City of Portland
Bureau of Development Services

Staff Presentation to the
Portland Design Commission

Design Review Hearing #2
LU 14-230014 DZM AD
Block 136

January 22, 2015

ADJUSTMENT

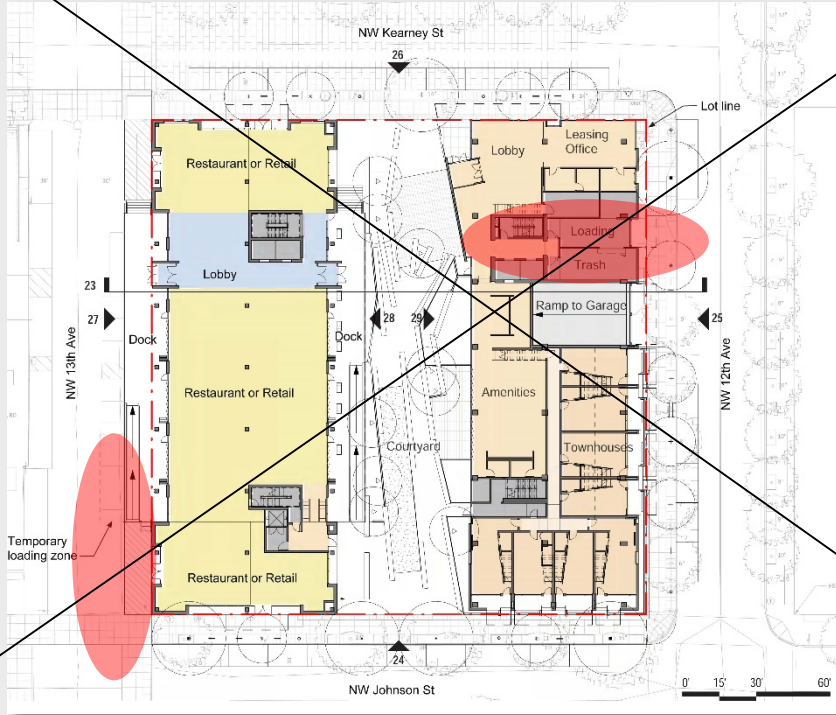
33.266.310.C. Number of Loading Spaces

Two (2) loading spaces meeting Standard A are required. Project proposes one (1).

MODIFICATION 1

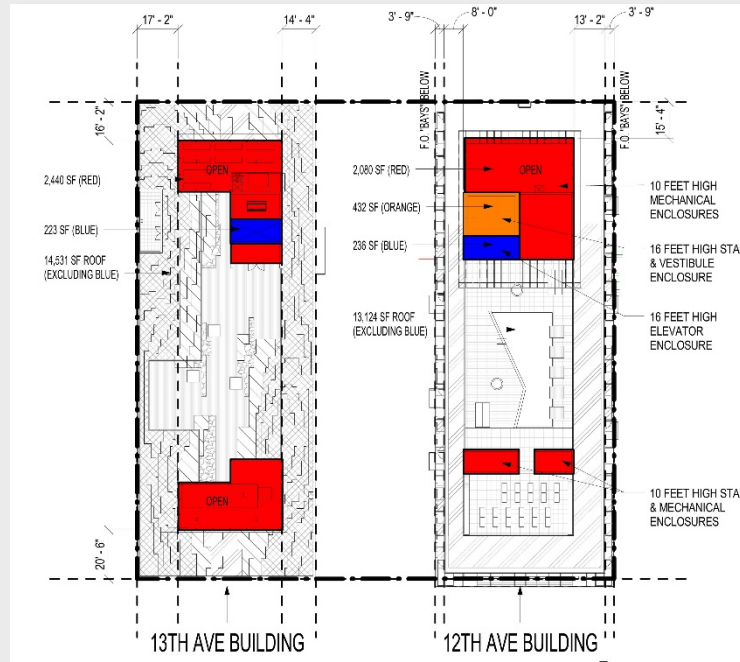
33.140.210.B.2. Rooftop Access & Mechanical – STAFF SUPPORTS

Set back – 15' from roof edges | 12th Ave Bld – 13' from 12th Ave, 8' from Courtyard.

Projection Height – 10' max | 12th Ave Bld – one 13' projection (air unit).

Rooftop Coverage – 10% max | 12th Ave Bld – 18.8%, 13th Ave Bld – 16.5%.

MODIFICATION

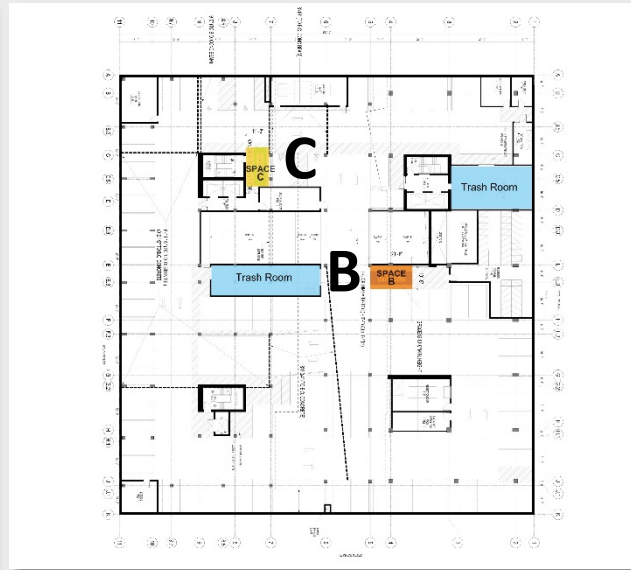
33.266.310.C. Quantity of Loading

Required: 2 Std A | Proposed: 1 Std A

Size of Loading

A – 35'x11'-5"x10'

B – 18'x9'x10'

C – 18'x10'x18'-11"

COURTYARD

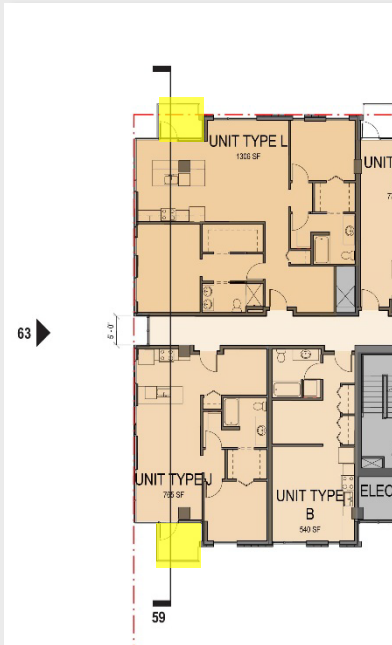
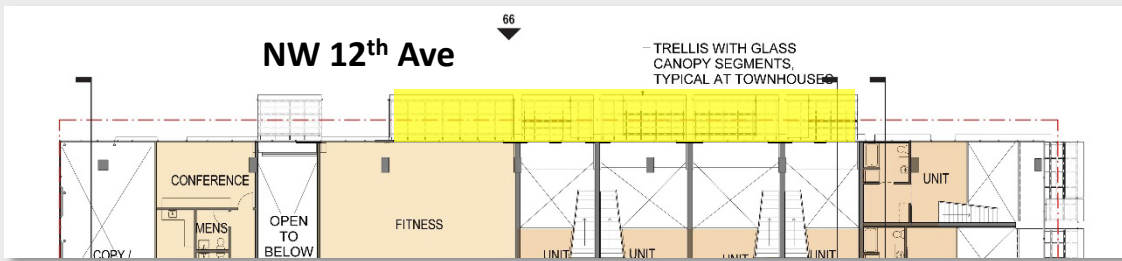
- Log timber joining details
- Flush logs
- Study "pinch point"

- Canopies on 12th should cover sidewalk
- SW & SE corners seem heavy
- Larger decks on 2 bdrs

- More weather protection
- Projecting bays?
- More shadow play?
